**LEBANON PLANNING BOARD
OCTOBER 10, 2022 - 6:30 PM
COUNCIL CHAMBERS, CITY HALL OR
REMOTE VIA VIRTUAL PLATFORM
LEBANONNH.GOV/LIVE**

- C. *REVISED* - LWM Residential LLC, 1 Foundry Street (Tax Map 91, Lot 263), 25 Mechanic Street (Tax Map 91, Lot 267), and 43 Mechanic Street (Tax Map 106, Lot 34), zoned LD:** Request for Site Plan Review of a phased, 196-unit multi-family development including a new 4-story, 27-unit multi-family building with a parking garage on the ground floor at 43 Mechanic Street; a new 4-story, 31-unit multi-family building with a lower-level parking garage at 25 Mechanic Street, to be merged with 1 Foundry Street; and, at 1 Foundry Street, the renovation of the existing Woolen Mill building into 49 dwelling units, the renovation of the existing commercial building and boiler building into amenity spaces, construction of a 2-story parking structure, and construction of a new 5-story, 89-unit multi-family building with a lower-level parking garage, together with associated site improvements. Applicant also requests a Conditional Use Permit pursuant to Section 307.8.A to allow an increase in the maximum permitted building height. PB2022-36-SPR - Continued from S

COVER SHEET

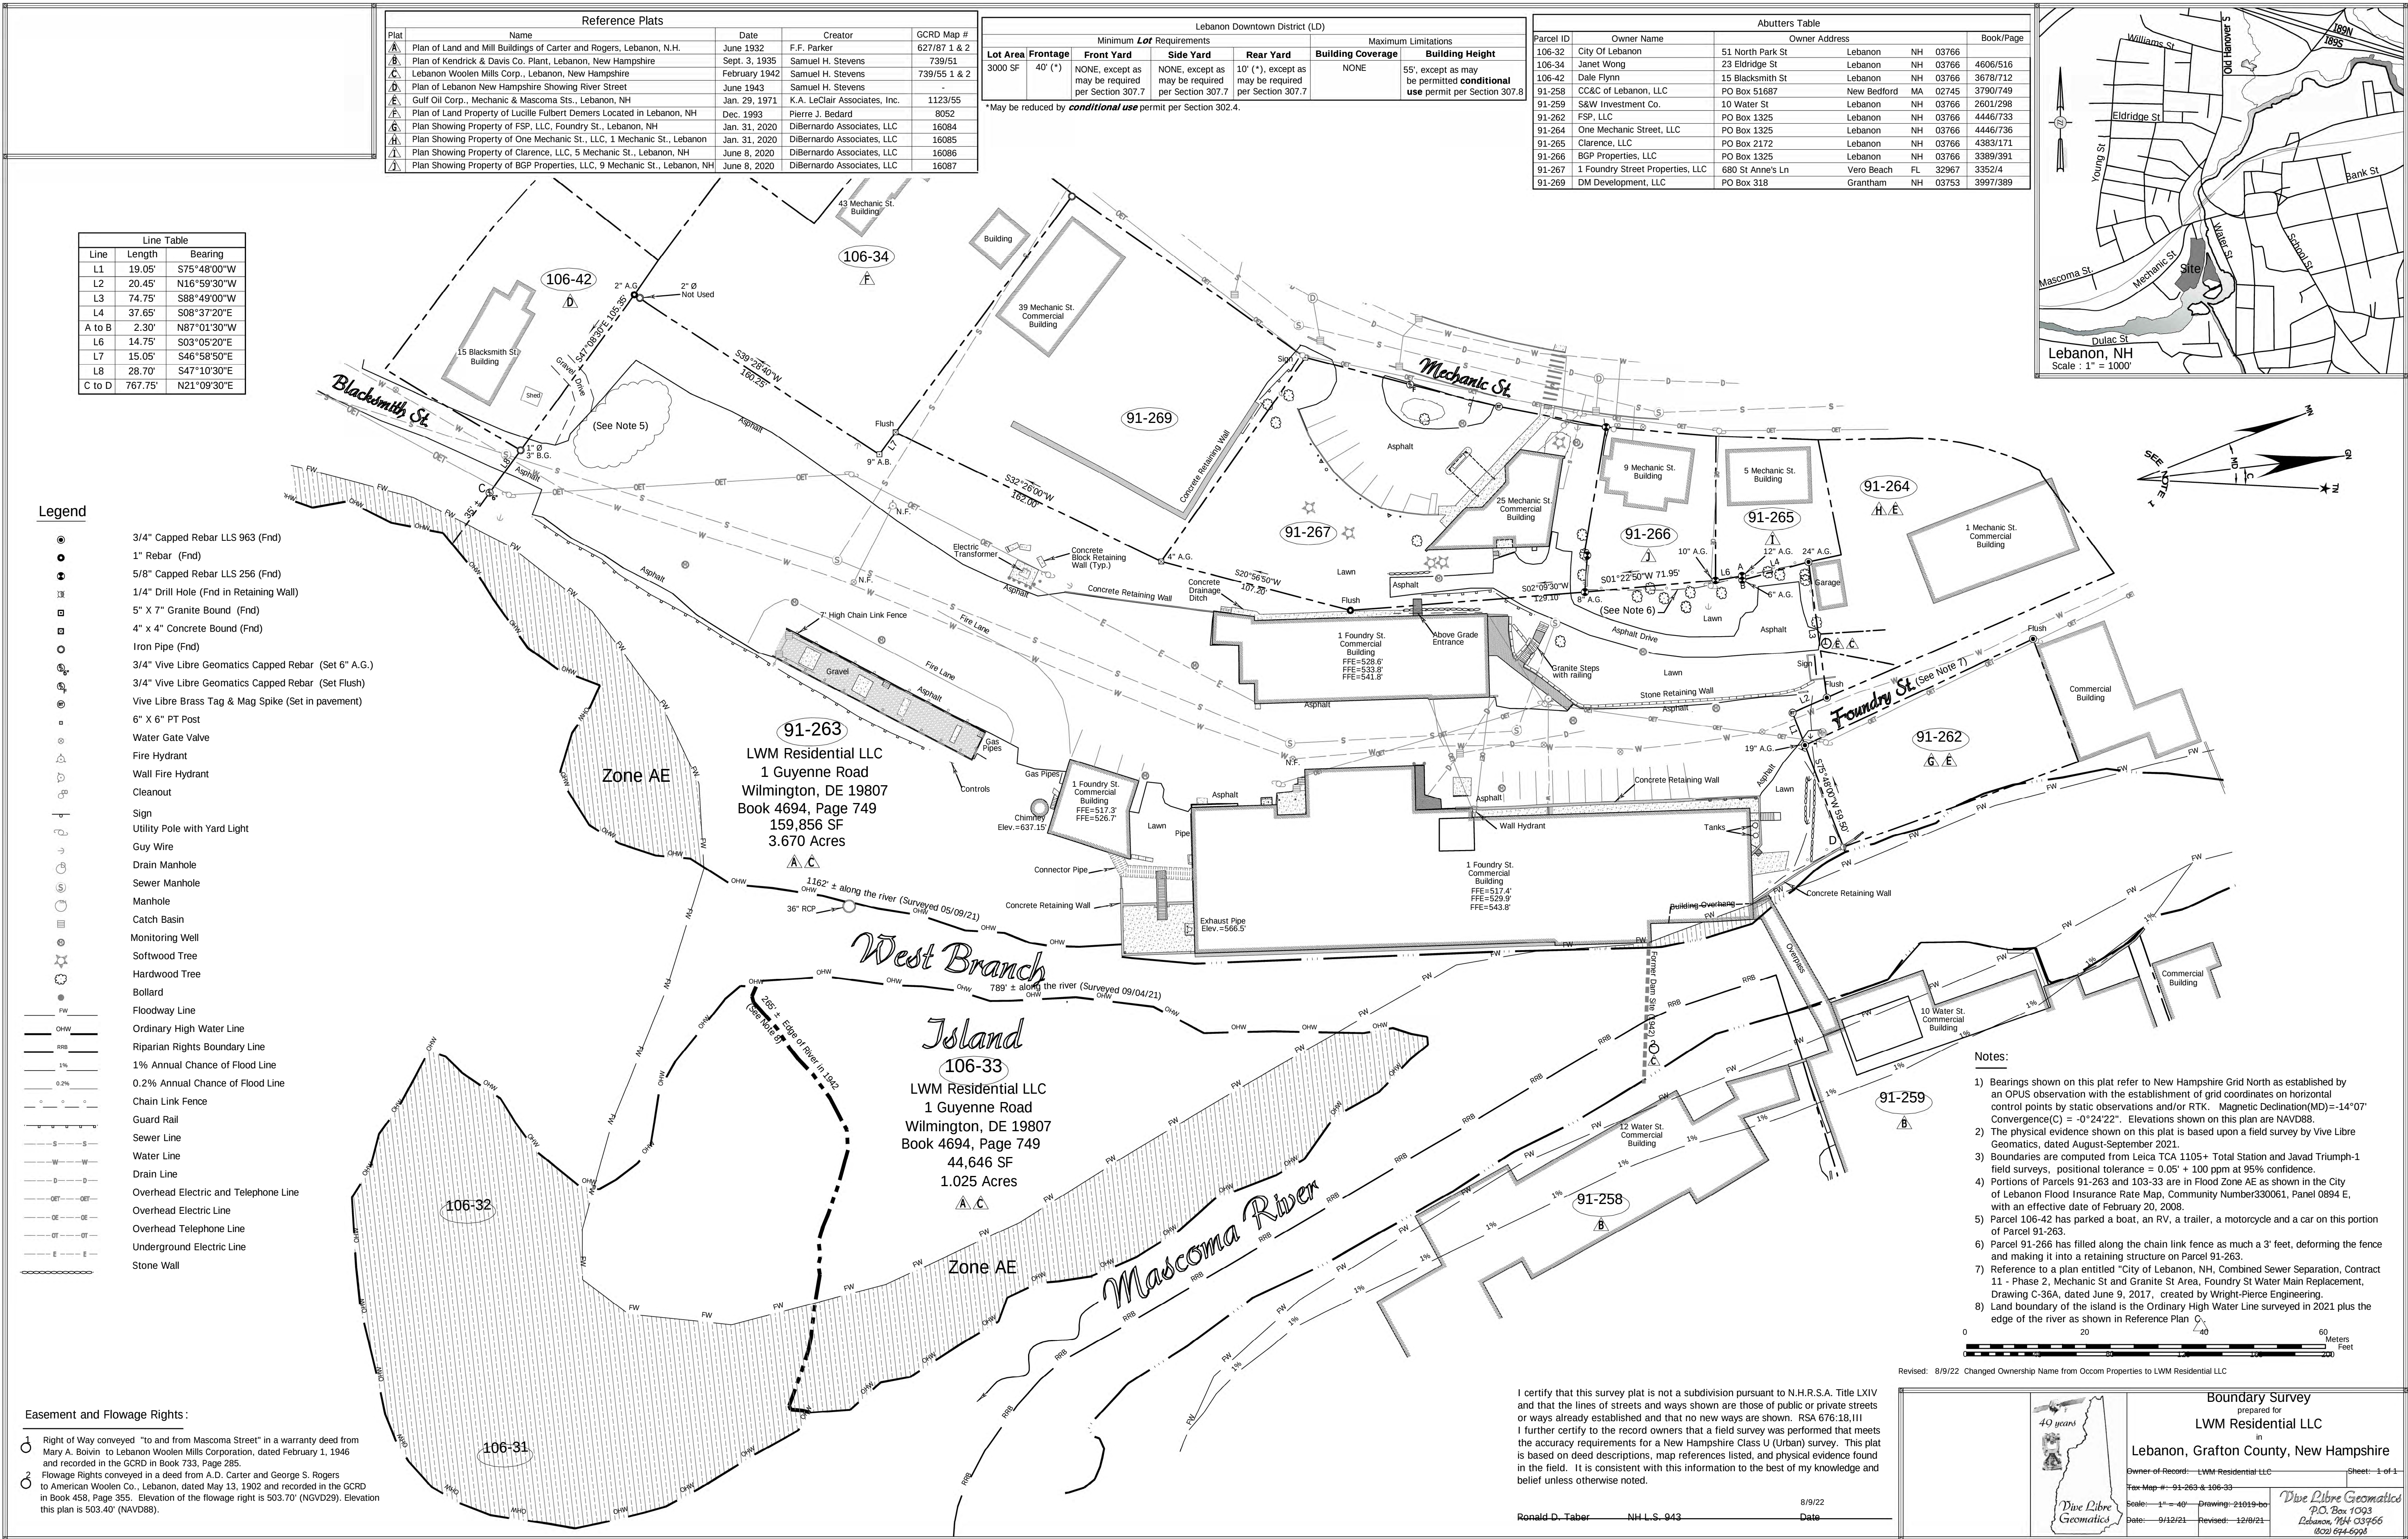
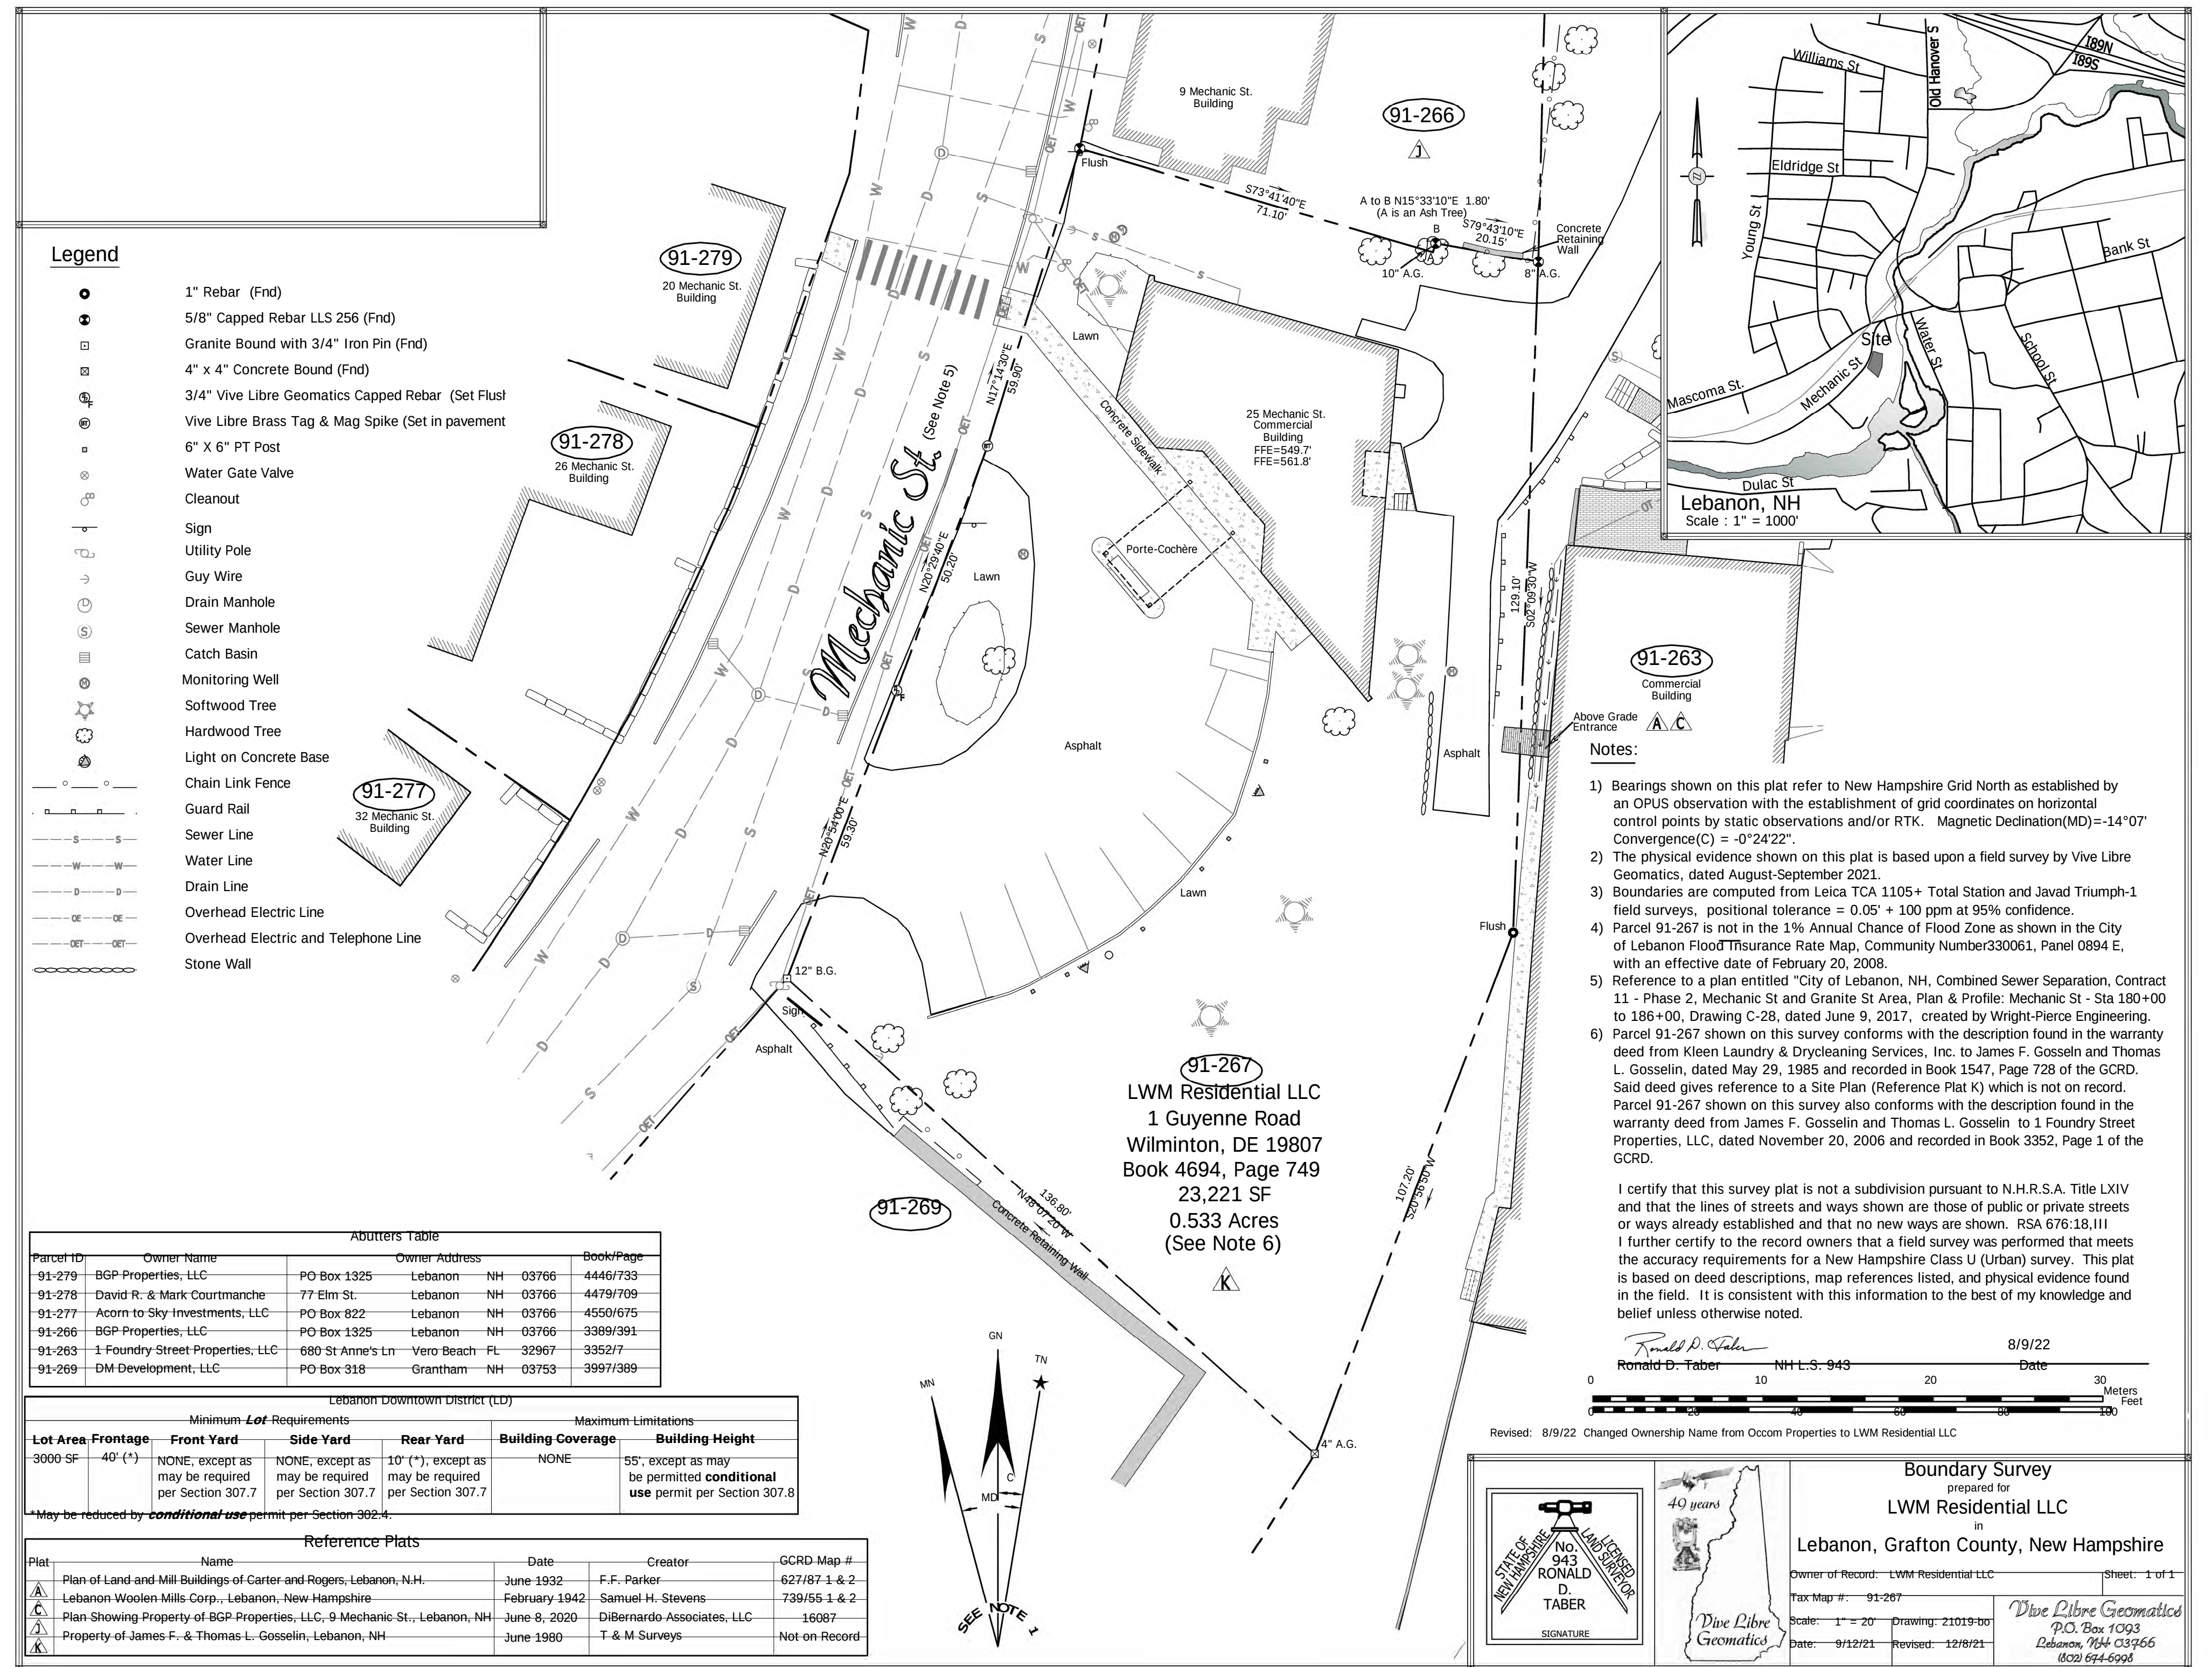
1. We continue to recommend the building height dimension for Building 3 specified in the Zoning Table provided on Sheet C-000 (55' – 8") be reconciled with updated architectural elevations (Sheet A-201), which suggest a building height of 60'-6".
